**CONCEPTUAL MASTER
POTABLE WATER SYSTEM REPORT
FOR
SERENO CANYON**

City of Scottsdale Water Resources Department

Basis of Design Review Comments

Project: Sereno Canyon

PLATE 4

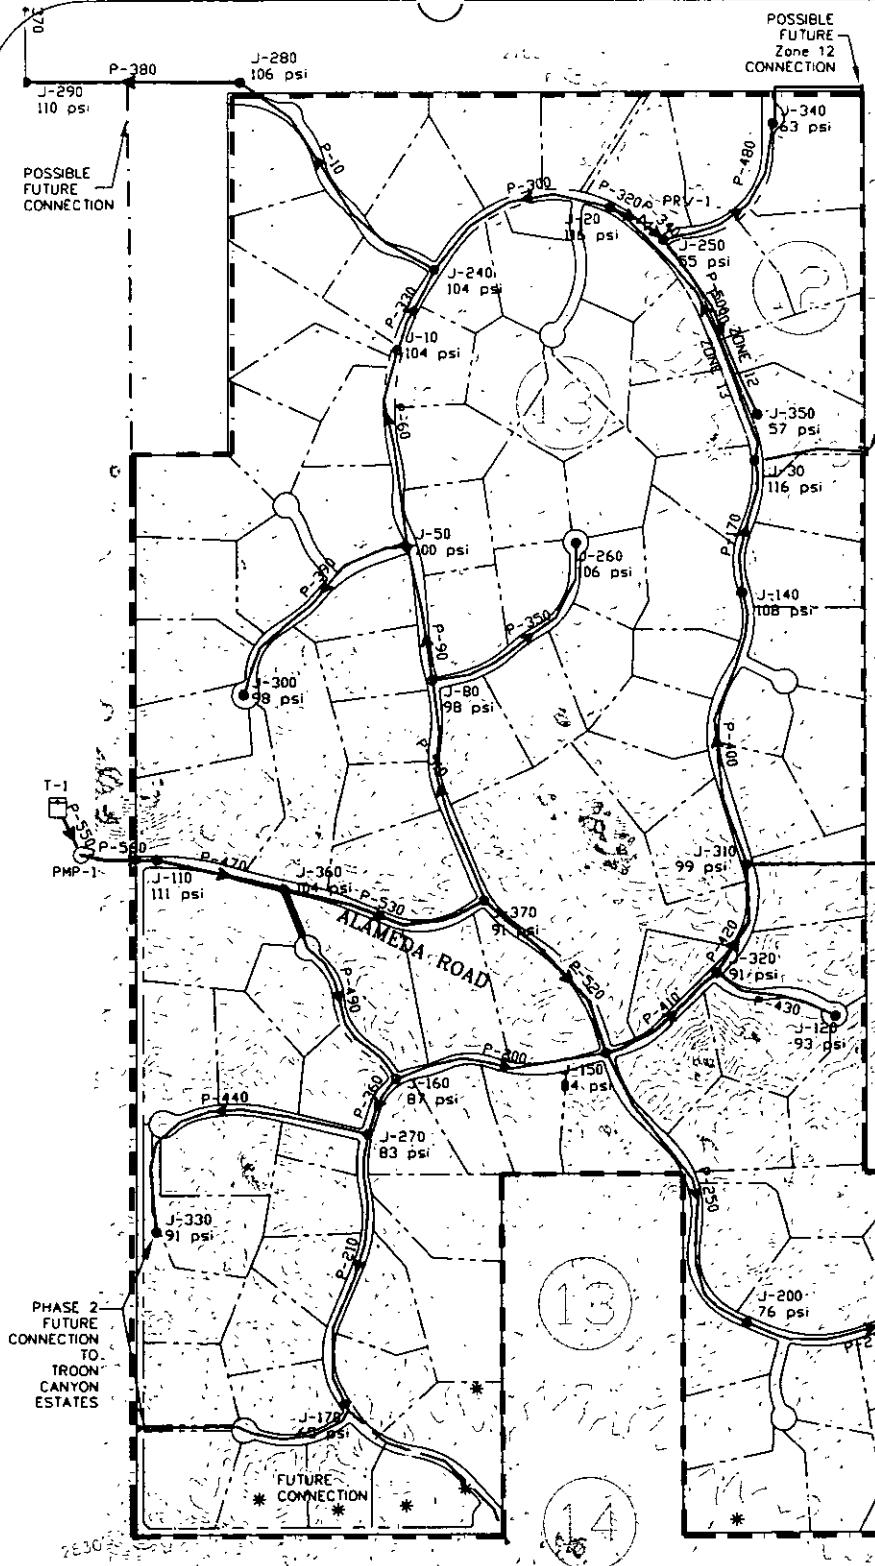
5. Plate 4, Option 1 is to include a line from the cul-de-sac off pipe 390 to the northwest property line for a future connection to the adjacent property. A stub to the property line shall be included off node J-310. A water line will be installed along the 128th Street frontage to this project.
